## Product Change Notification / CAAN-22MOEJ783

CCB 6816 Final Notice: Qualification of NSEB as a new assembly site for HV9150K6-G, MD1820K6-G, MD1821K6-G and MD1822K6-G catalog part numbers (CPN) available in 16L VQFN (3x3x0.9mm) package.

### PCN #:CAAN-22MOEJ783

# LEAD FRAME COMPARISON

## CARC

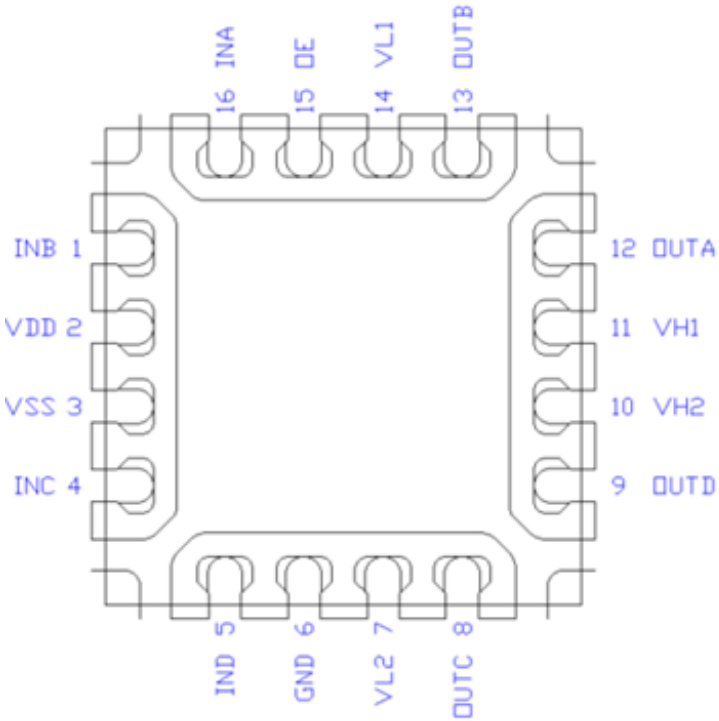
Wire Material	Au
Lead Frame Material	A194
Lead-Frame Paddle Size	83x83 mils
DAP Surface Prep	Ag spot

## NSEB

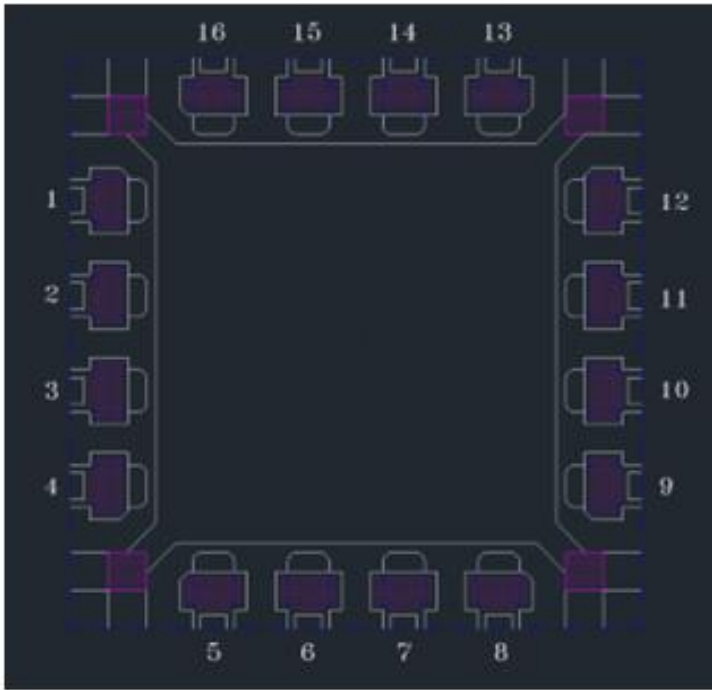
Wire Material	Au
Lead Frame Material	EFTEC-64T
Lead-Frame Paddle Size	83x83 mils
DAP Surface Prep	Ag on lead only
